TECHNICAL BULLETIN

DOCUMENT NUMBER:- 913-6 TB 1- 0908

Document name:- "Failure of Differential mounting bolts on bolster"

This is applicable to all 913-6 Anderson Industries LHD vehicles or similar bolster designs

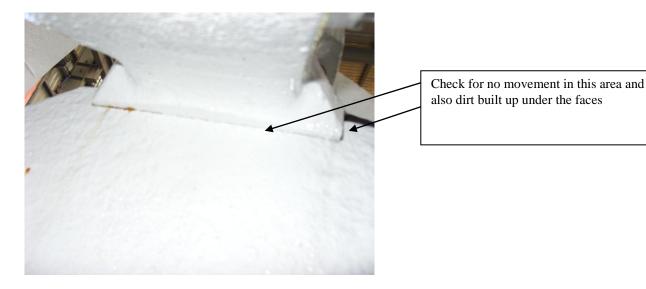
As can be see from this photo the top end of the bolster appears to have some compression marks on the face between the differential and the bolster, while the bottom end only had loose dirt sitting on the faces indicating no compression between the faces.

- Tensile strength 150,000 lb
 - U Yield 130,000 lb
 - Proof test 120,000 lb
- 5. All faces to be checked to ensure no movement is evident between the bolster frame and the differential as shown in photo below.

- 7. All bolts to be checked for tension every 250 hours of operation. This could be done by simply a tap with the hammer. Every 1000 hours should use a tension wrench.
- 8. If bolts found loose faces between the bolster frame and the differential are to be cleaned before re-tensioning.
